DRB-22-08 DDO-22-37
(T22SA00231)

DESIGN DEVELOPMENT OPTION (DDO) APPLICATION For Landscaping/Screening Substitutions

5 STAR COLLISION PAINT & BODY SHOP

CDRC TRANSMITTAL
TO: Planning and Development Services Department, Plans Coordination
FROM: Anne Warner, RLA
PDS Landscape/Native Plant Preservation Section

1 LANDSCAPE PLAN

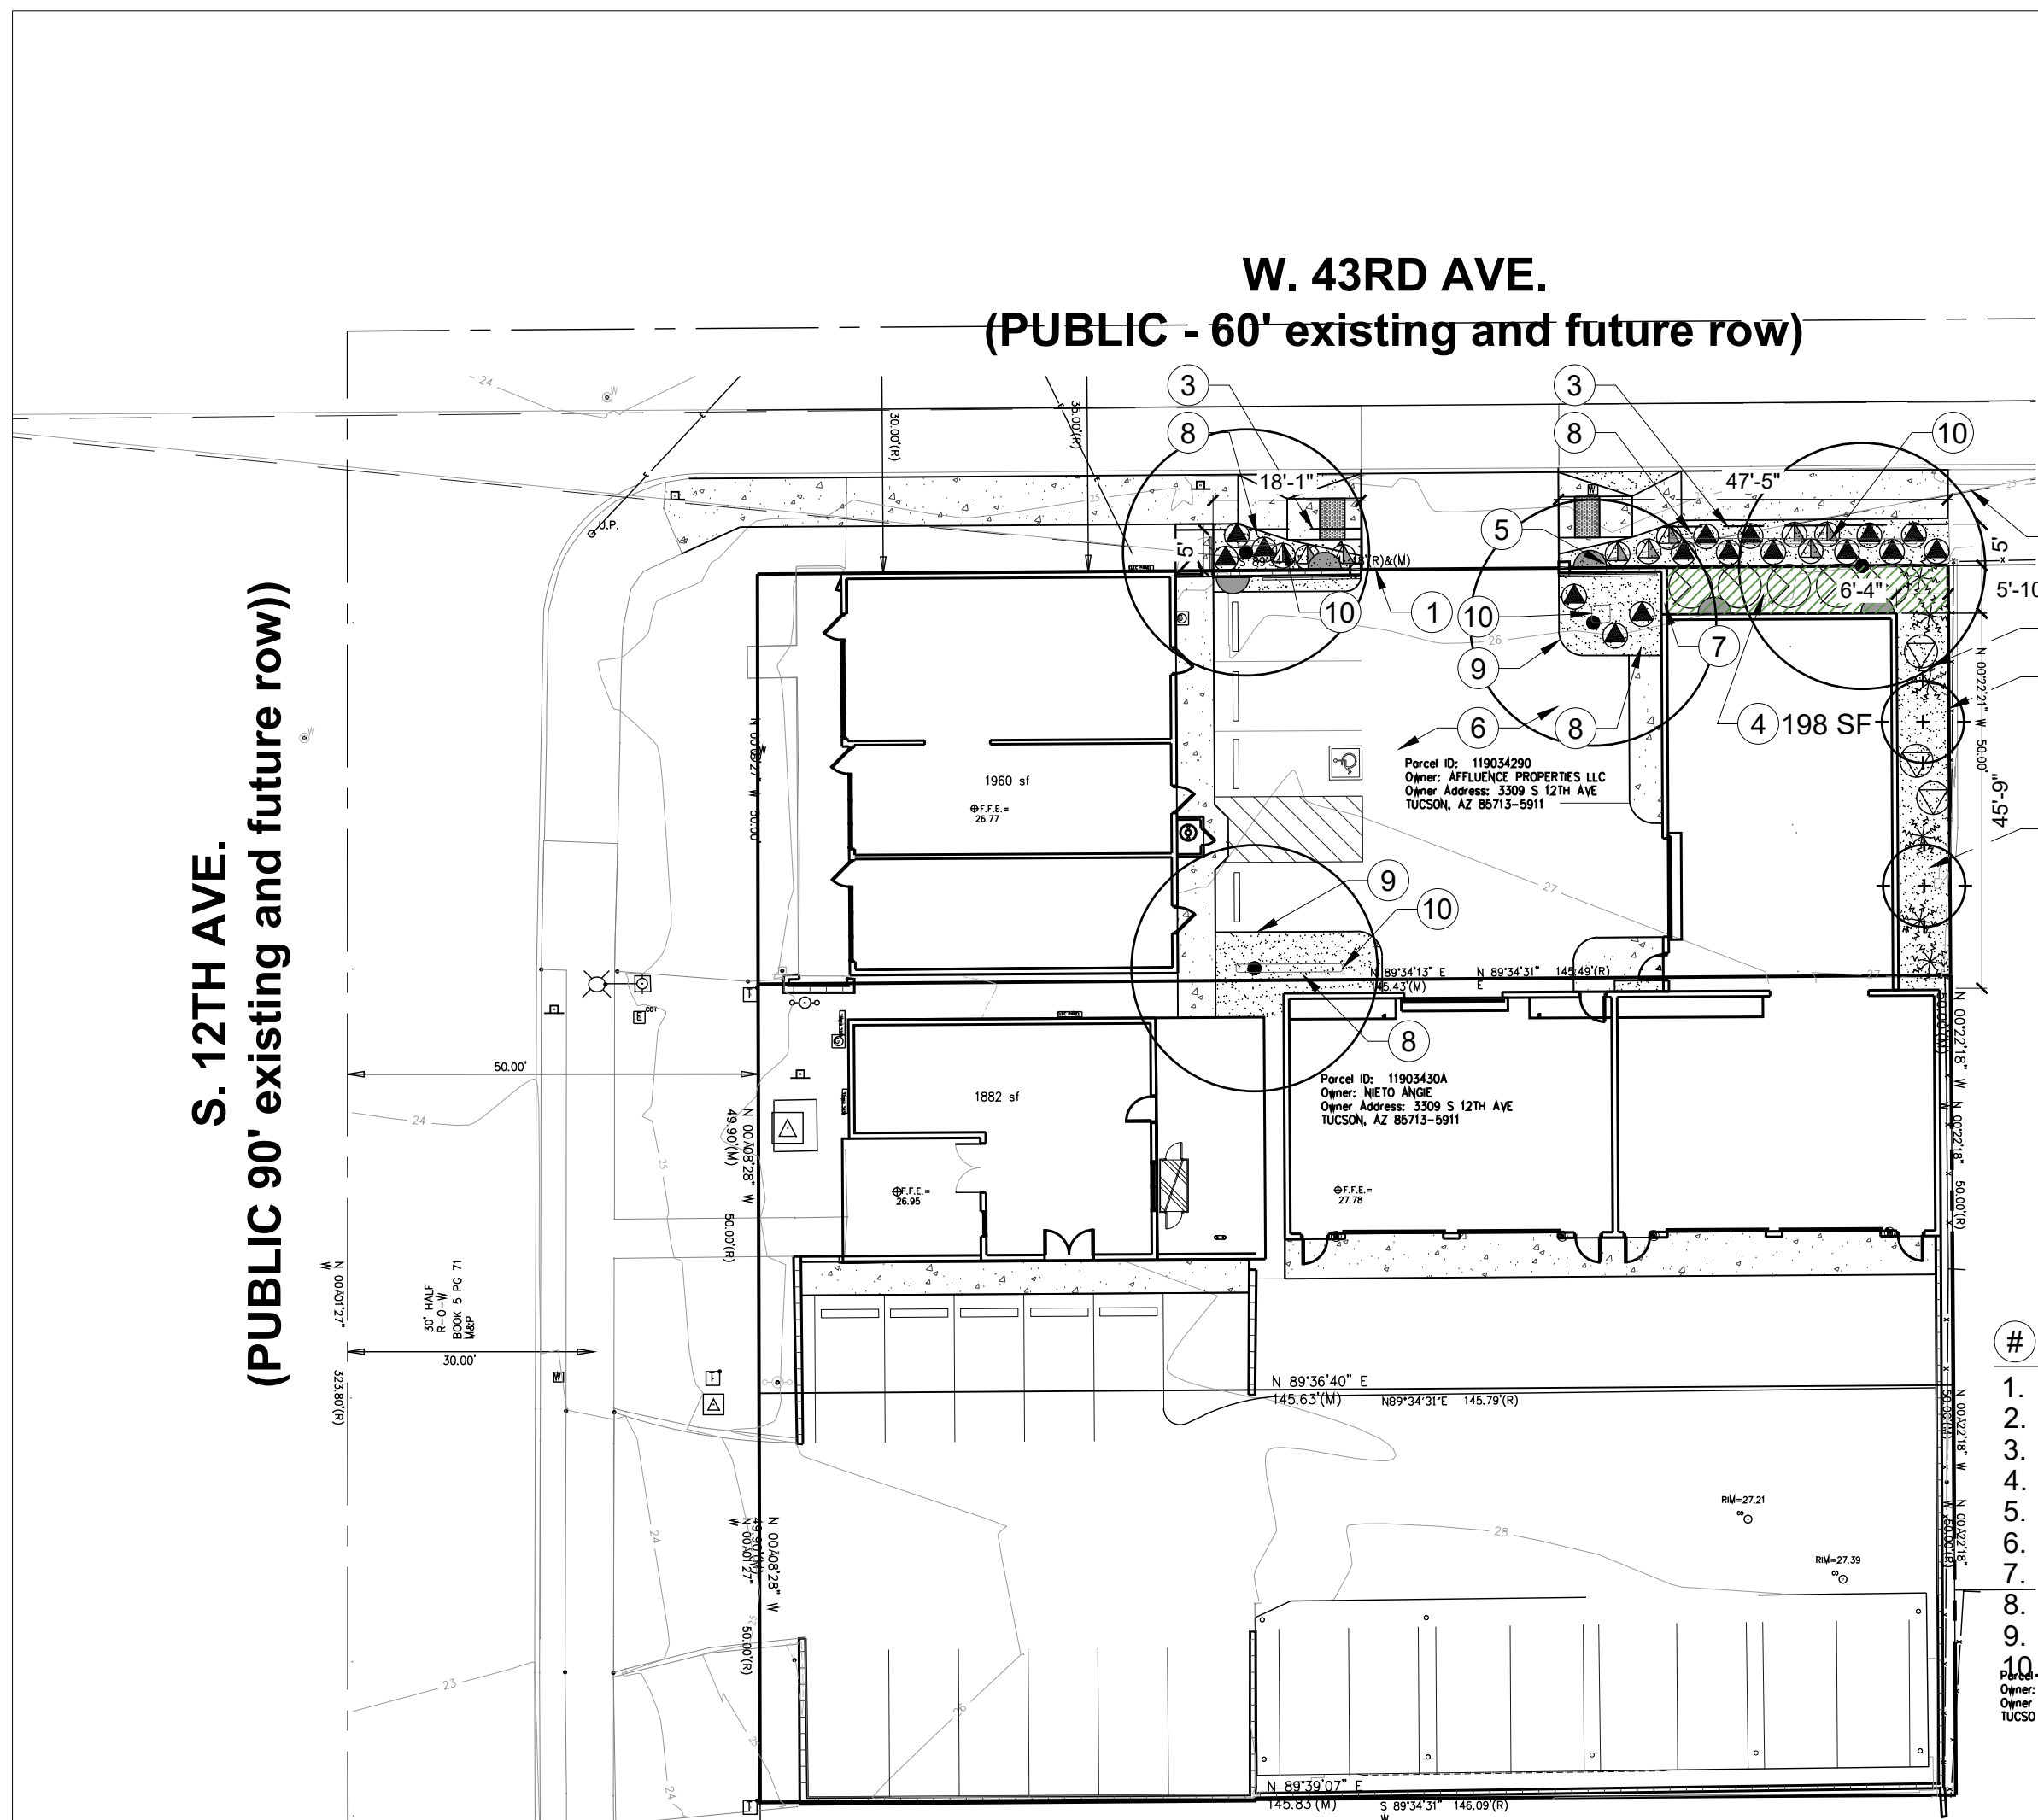
1. UDC 2-10.4.1 Identification and Descriptive Data - All improvements and site information, such as adjacent rights-of-way and property lines, shown on the landscape plan will be identical in size and location to those shown on the base plan (site plan or tentative plat). Should amendments be required to the base plan through the review process, the same amendments will be made to the landscape plan which will then be resubmitted along with the base plan.

3. One tree is required for the new parking area on the north, please make sure that it is shading asphalt.

4. A 10' landscape border is required adjacent to the parking area along W 43rd Ave. Also, a 30" screen is required for parking adjacent to streets.

5. The 5' landscape border is insufficient unless the intent is to use 5' of the right of way for landscape. Please clarify.

6. Please label the existing and future rights of way for all public streets, UDC 7.6.4.C.2.a.

7. Please indicate the installation of a private submeter if a separate irrigation meter is not being provided. UDC Technical Standards 4-01.6.1.A.1.

8. Please add a detail to show depressed landscape areas or indicate with notes.

9. Per Admin. Manual 2-10-4.2.D, provide page/detail reference to civil drawings/details that show bike racks, walkways, and screening/retaining walls on landscape plans. See civil drawing is not sufficient.

10. Provide a detail to show tree planting with root barrier adjacent to walkways.

11. A Commercial Rainwater Harvesting plan is required. UDC Technical Standards Manual - Section 4-01.0.0. and Section 5-01.0.0 Landscaping and Screening. Demonstrate how water harvesting is being maximized.

12. Identify the point of drainage off roof areas, amount of flow, and disposition of flow.

13. Identify curb inlets/splash pads to landscape areas on water harvesting or landscape plans.

A landscape DDO is required for the east side of the property. Notes say that this required interior landscape border is 10', but only measures 6'.
